To: All Prospective Bidders  
From: Mary P. Mooney, Purchasing Agent  
Date: 8/18/23  
RE: ADDENDA #2: BID #23-13 Boardwalk Reconstruction Project  
Texas Avenue to Columbia Place

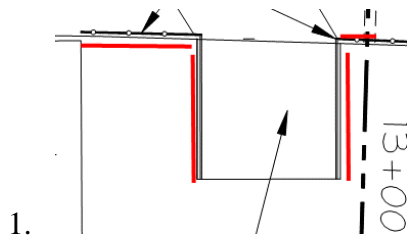
41. RIBBON BOARD

- i. The bidder shall include labor and miscellaneous materials in their BASE BID for +/- 260 LF of new “ribbon board” joists. Lumber will be supplied by the City. (See S-2 for locations)**

- i. The bidder shall include +/- 400 LF of labor and miscellaneous materials of new ribbon board joists. Lumber will be supplied by the City. (See S-2 for locations)**
